We have improved our product range and replaced our previous version of our hydraulic pumps, hand cranks and friction clutch.

### What is changed?

### Pump spindle shaft

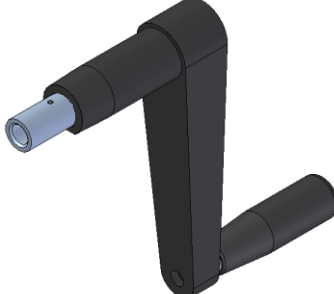
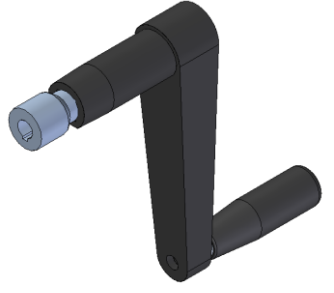
We will change to a hexagonal spindle design replacing the Spindle "Type A" flattened and Spindle "Type W" Woodruff spindle designed. By switching to a hexagonal spindle design, we have not only been able to improve the assembly process, but also simplify the product range. Simplifying the range helps to reduce complexity for customers and make it easier to select the right product.

<p><b>Pump PA / PB / PF</b></p>  <p><b>Typ «A» (flattened)</b> 10X.<b>0</b>XXXX</p> <p><b>Pump with HC</b> 31X.<b>2</b>XXXX</p>	 <p><b>Typ «W» (Woodruff)</b> 10X.<b>2</b>XXXX</p> <p><b>Pump with motor</b> 32X.<b>2</b>XXXX</p>	<p>→ werden ersetzt durch →</p>	<p><b>Pump PA / PB / PF</b></p>  <p><b>Typ «H» (Hexagon)</b> 10X.<b>3</b>XXXX</p> <p><b>Pump with HC</b>    <b>Pump with Motor</b> 32X.<b>3</b>XXXX    32X.<b>3</b>XXXX</p>
---	---	---	--

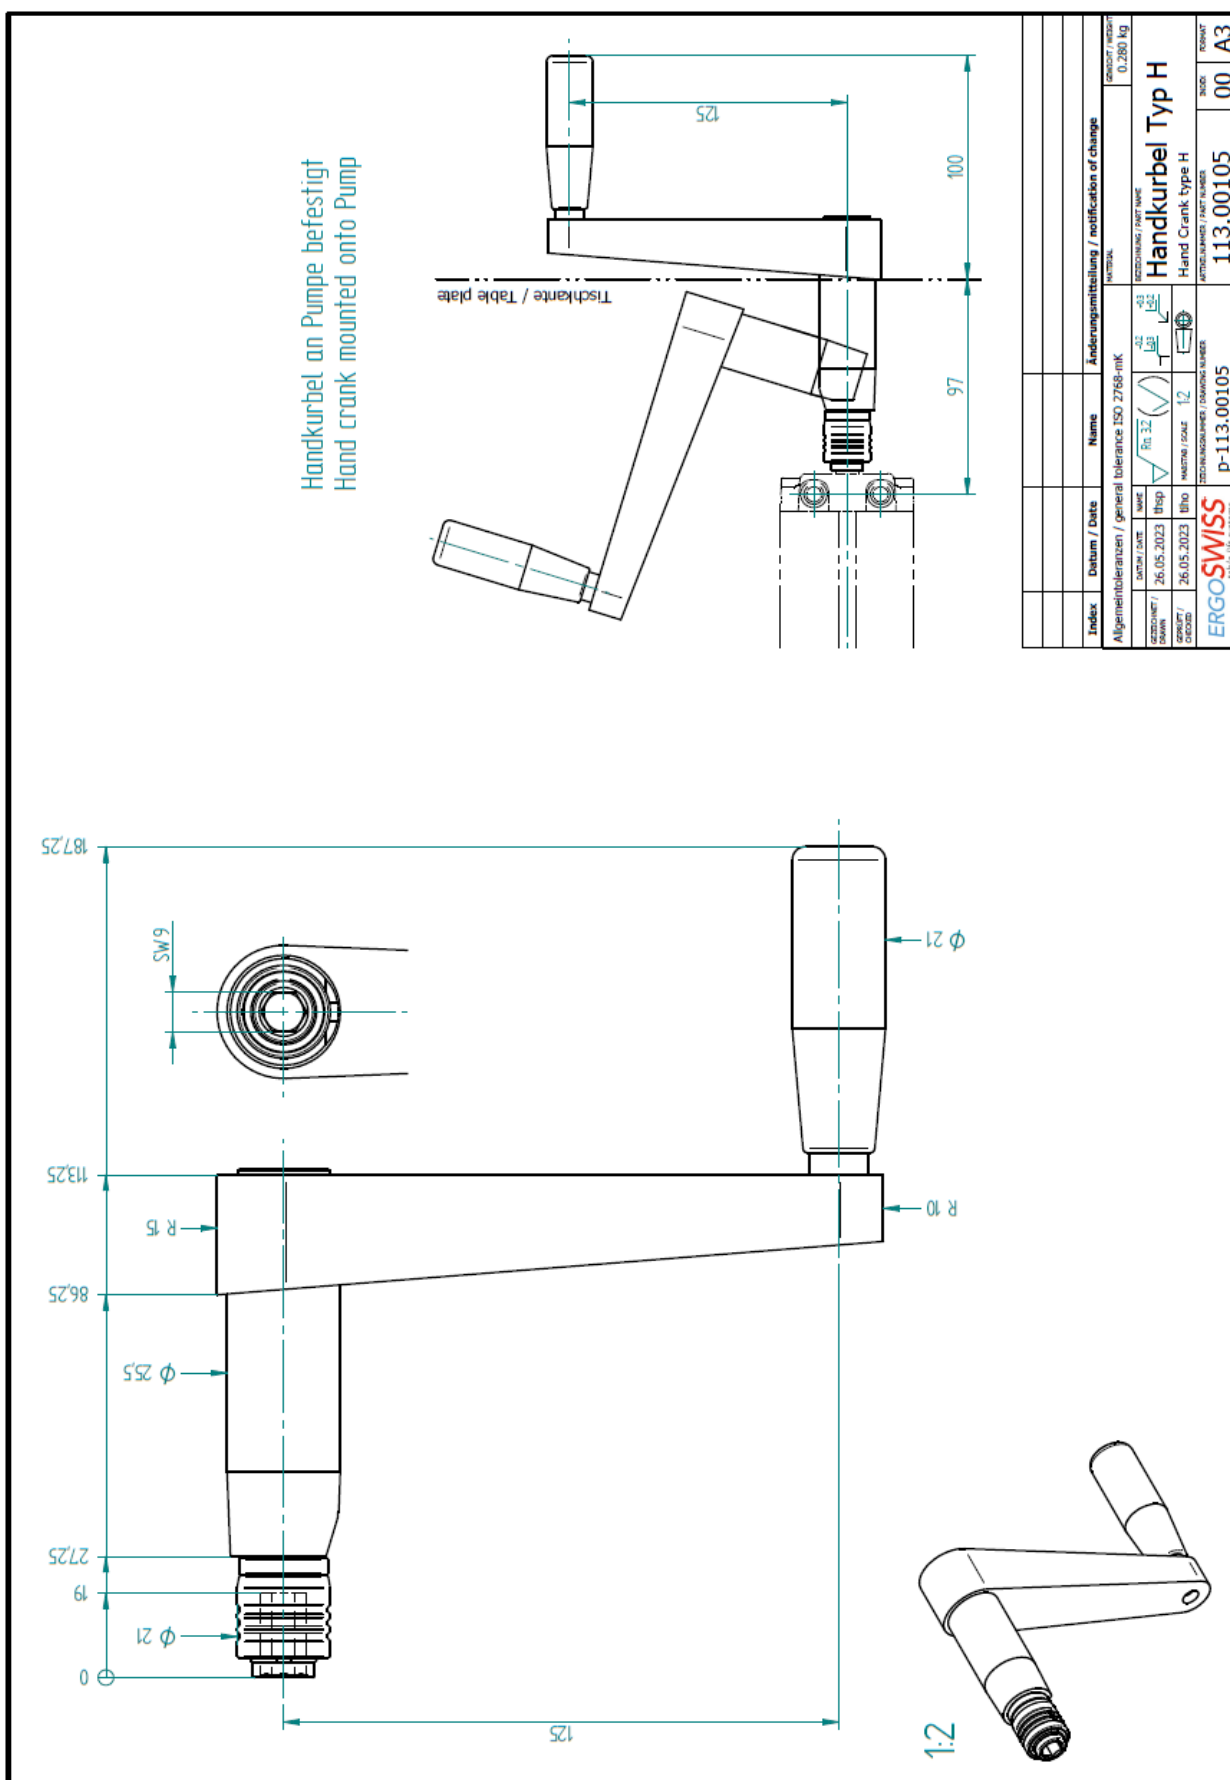
<p><i>*drilled + pinned</i></p>  <p><b>Hand crank foldable RF</b> 113.00090</p>	<p>→ will be replaced by →</p>	 <p><b>Hand crank foldable Hex RF</b> 113.00190</p> <p><i>Material 1.4104 (X12CrMoS17) Incl. threaded pin M5x6</i></p>
--	--------------------------------	--

ZEICHNUNGSNUMMER / DRAWING NUMBER a-113.30022
			ARTIKELNUMMER / ASSEMBLY NUMBER 113.30022
			INDEX 01
			FORMAT A4

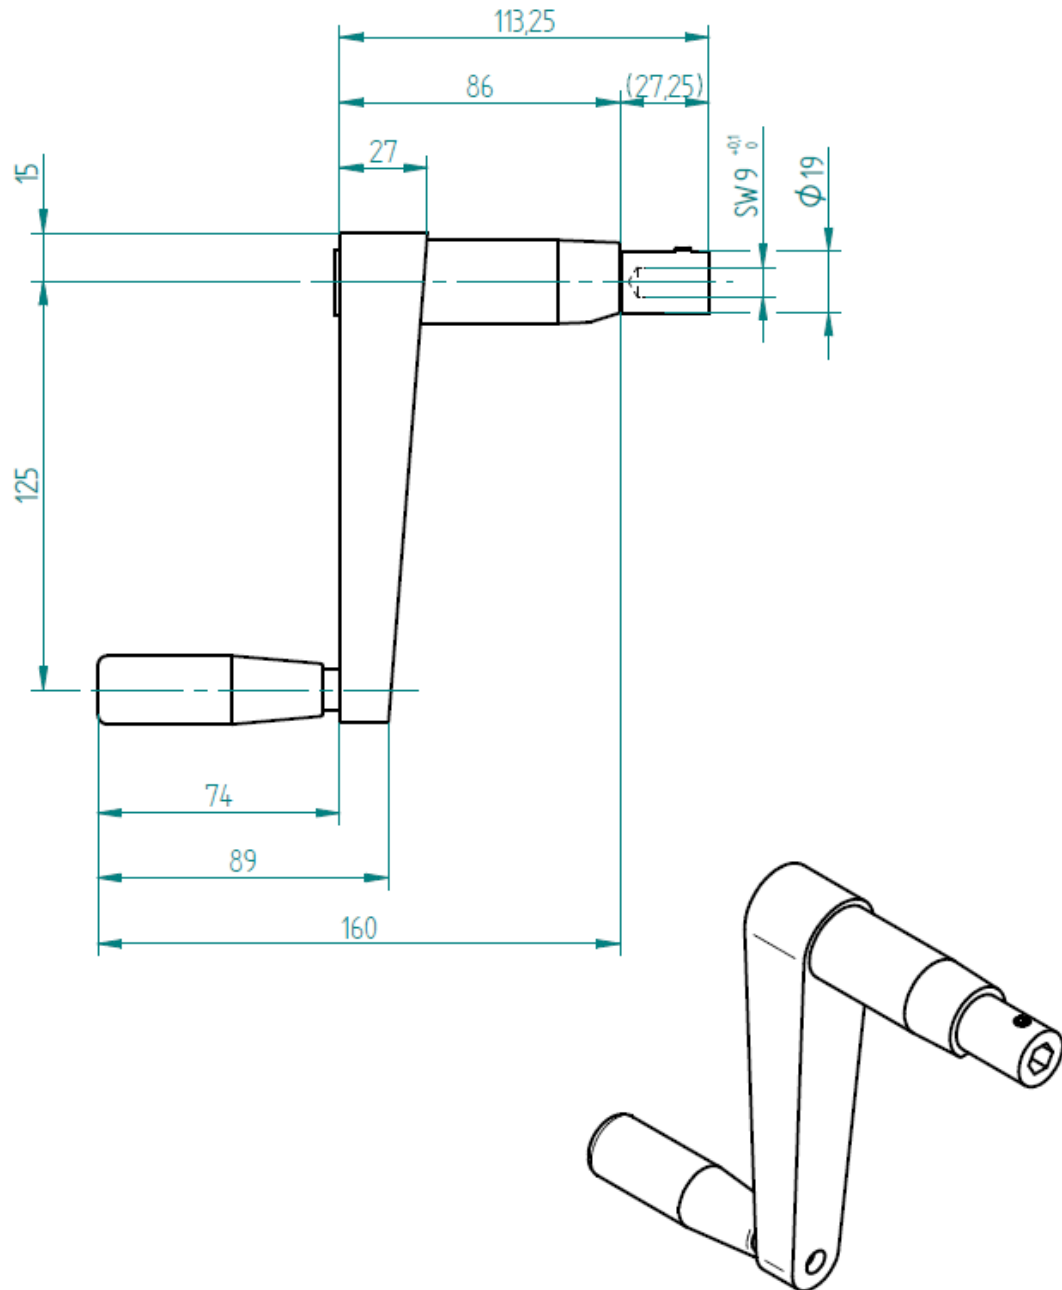
<p><b>Friction clutch 10Nm</b> 113.00022</p> <p><i>*Supplier K&amp;R drilled + pinned Länge 71mm</i></p>	<p>→ wird ersetzt durch →</p>	 <p><b>Friction clutch 10Nm RF (neu)</b> 113.<b>3</b>0022</p> <p><i>* In-house production screwed with grub screw Length 62mm</i></p>
--	---------------------------------------	---

01	17.07.2024	hafi	1223: Neu mit 2x Gewindestift M3x8
Index	Datum / Date	Name	Änderungsmittelteilung / notification of change
GEZEICHNET / DRAWN	Datum / Date	Name	BEZEICHNUNG / ASSEMBLY NAME
	07.02.2024	hafi	Rutschkupplung H 10 Nm kpl.
GEPROBT / CHECKED	07.02.2024	mito	Safety clutch H 10 Nm cpl.
			GEWICHT / WEIGHT 0.189 kg
			MAßSTAB / SCALE 1:1
